ADDENDUM NO. 03
December 19, 2025

To Drawings and Specifications dated December 05, 2025.

PKG 3B – GPHS ATHLETICS, ACADEMIC & MULTI-PURPOSE FACILITY

Prepared by: PBK
11 Greenway Plaza, 22nd Floor
Houston, TX 77046-1104
PBK Project No: 240539

01 LEVEL 3 - AREA F NEW MULTIPURPOSE FACILITY CEILING PLAN
1/8" = 1'-0"

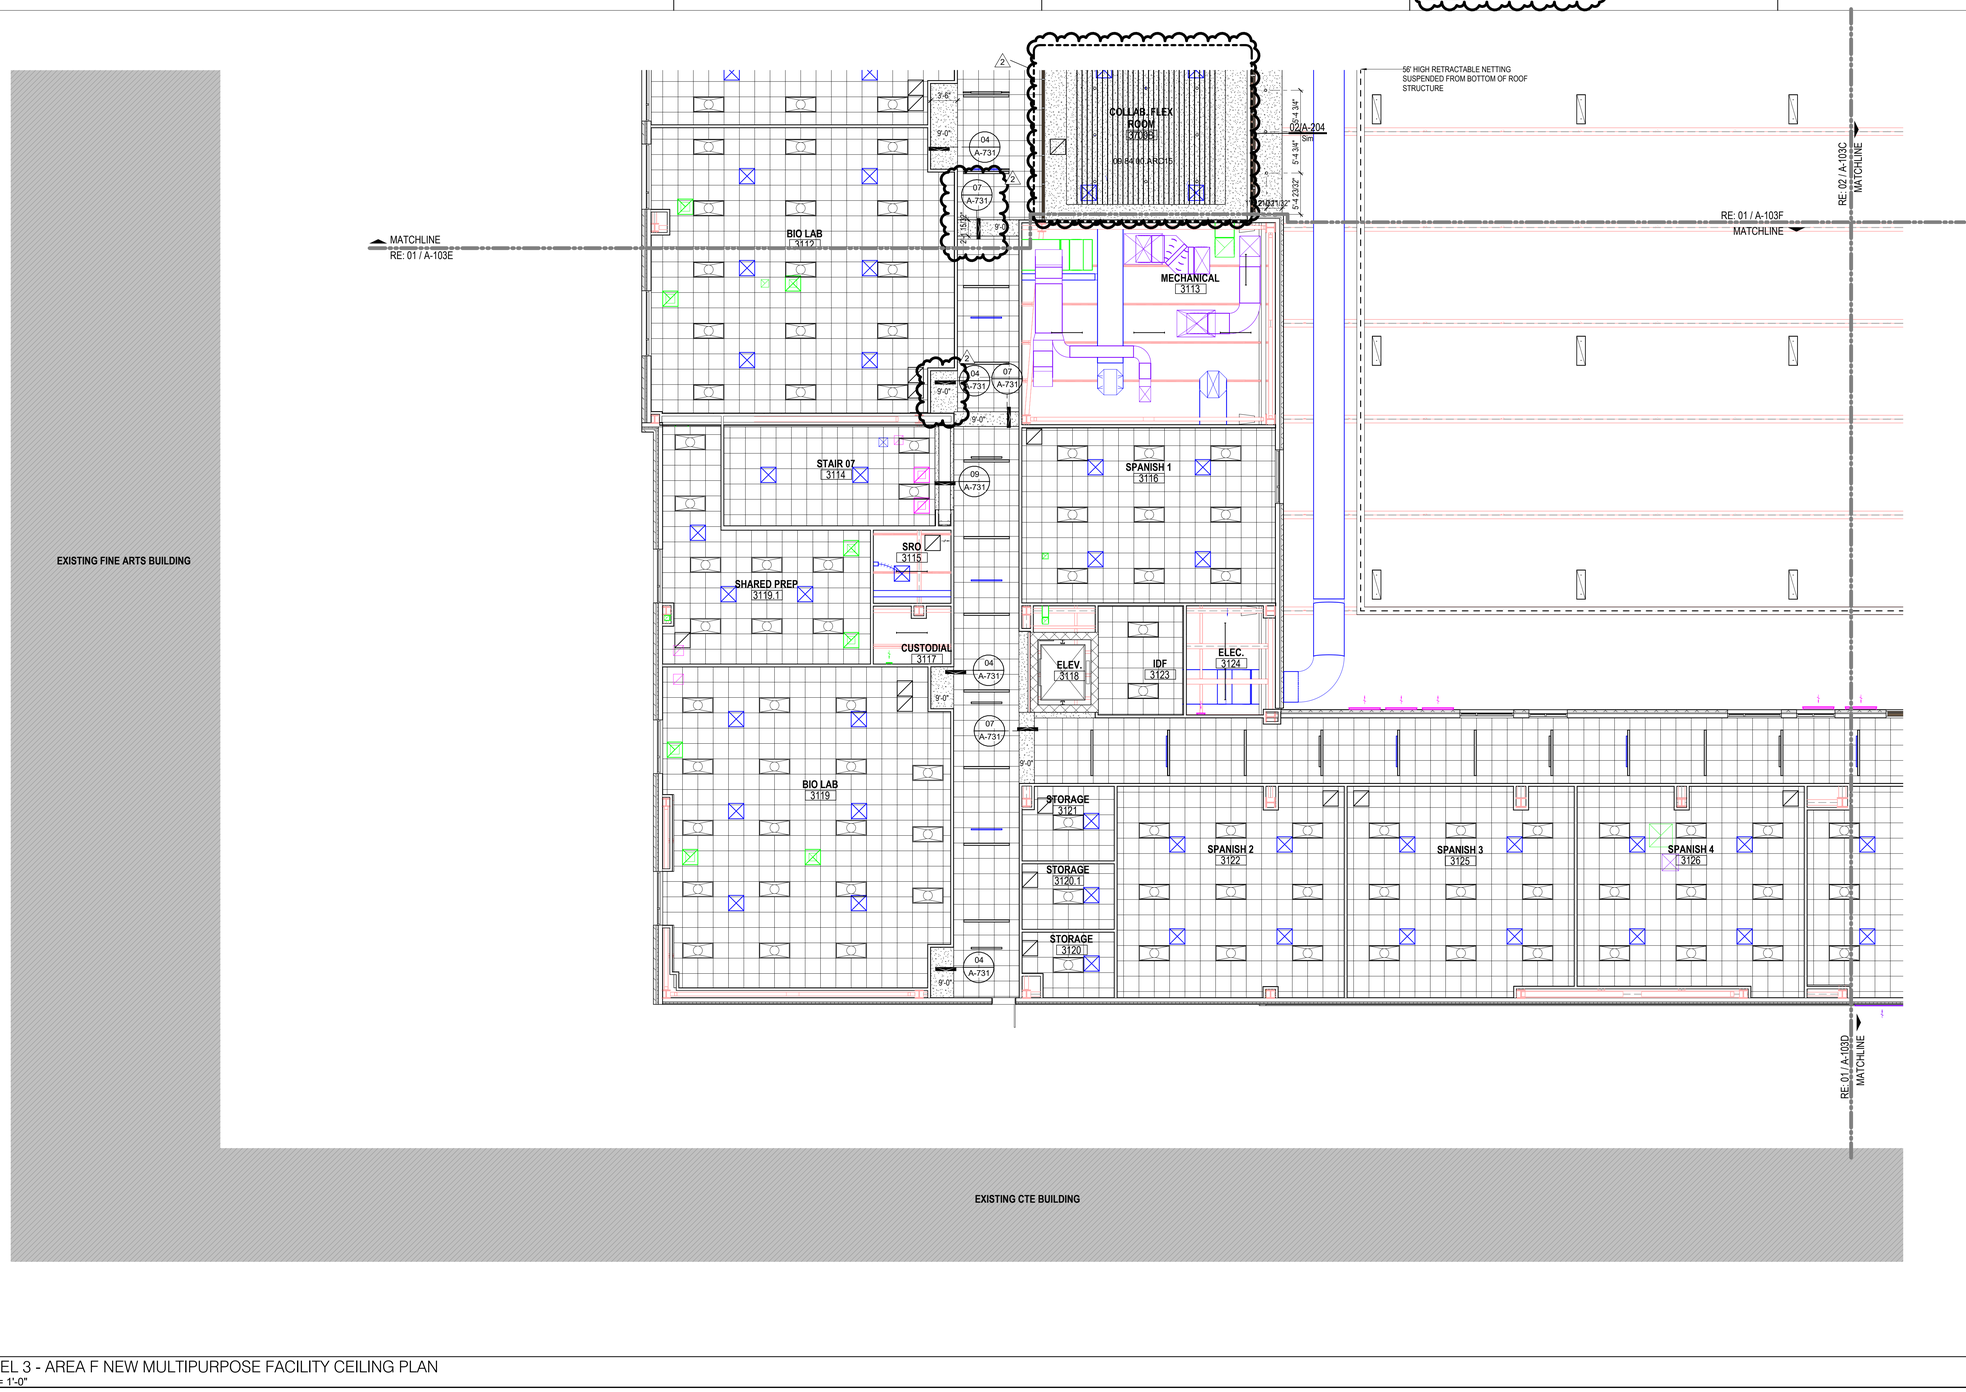
Item No. 37 A-203F – Level 3 – Area F Ceiling Plan
A. Added baffles/gyp to the ceiling plan for the collab/flex space 3700B
B. Added recessed can downlights
C. Replaced detail 07/A-731
D. Fixed ceiling outside of Bio Lab 3112, added ceiling detail 04/A-731
